ADDENDUM NO. [2]

Date: September 17, 2019

**RE: SCHOOL DISTRICT OF LA CROSSE
7 RIVERS CHARTER SCHOOL
225 5TH AVE SOUTH
LA CROSSE, WI 54601
HSR 19003**

12. Sheet A102 SECOND FLOOR REMODEL PLAN 30 x 42 attached hereto

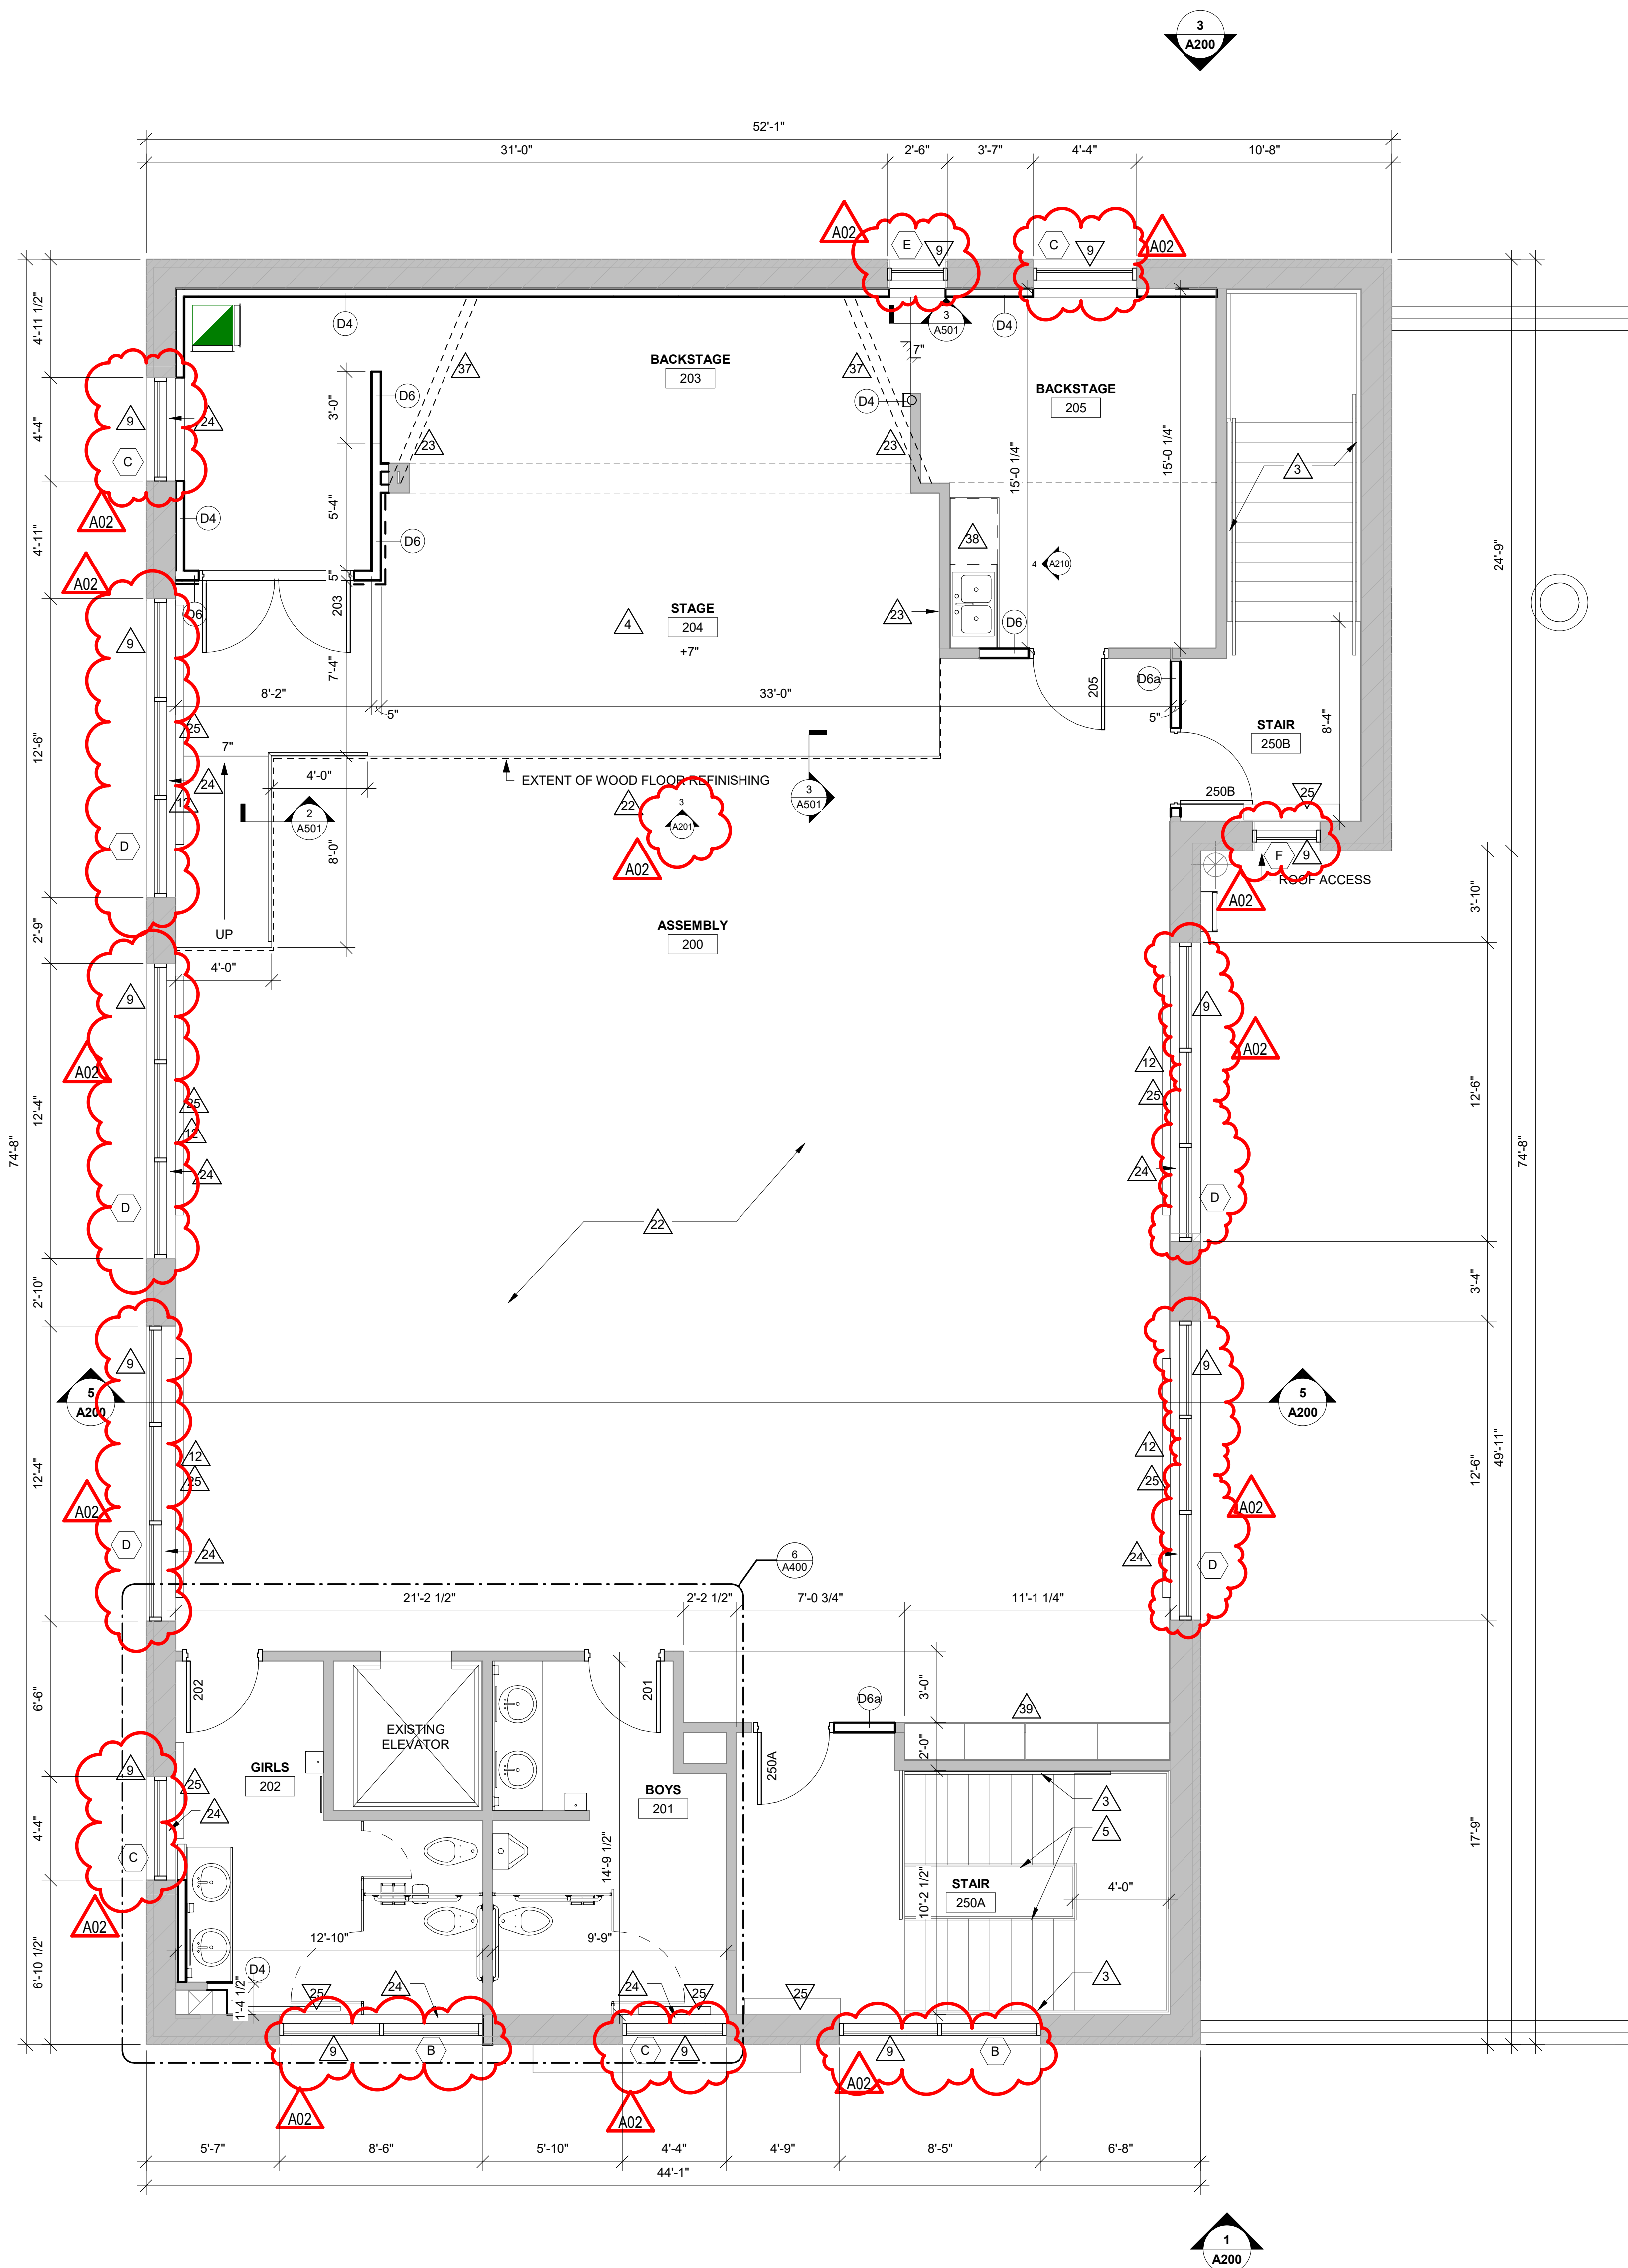
- a. Revisions clouded on Drawing.
- b. New windows shown.
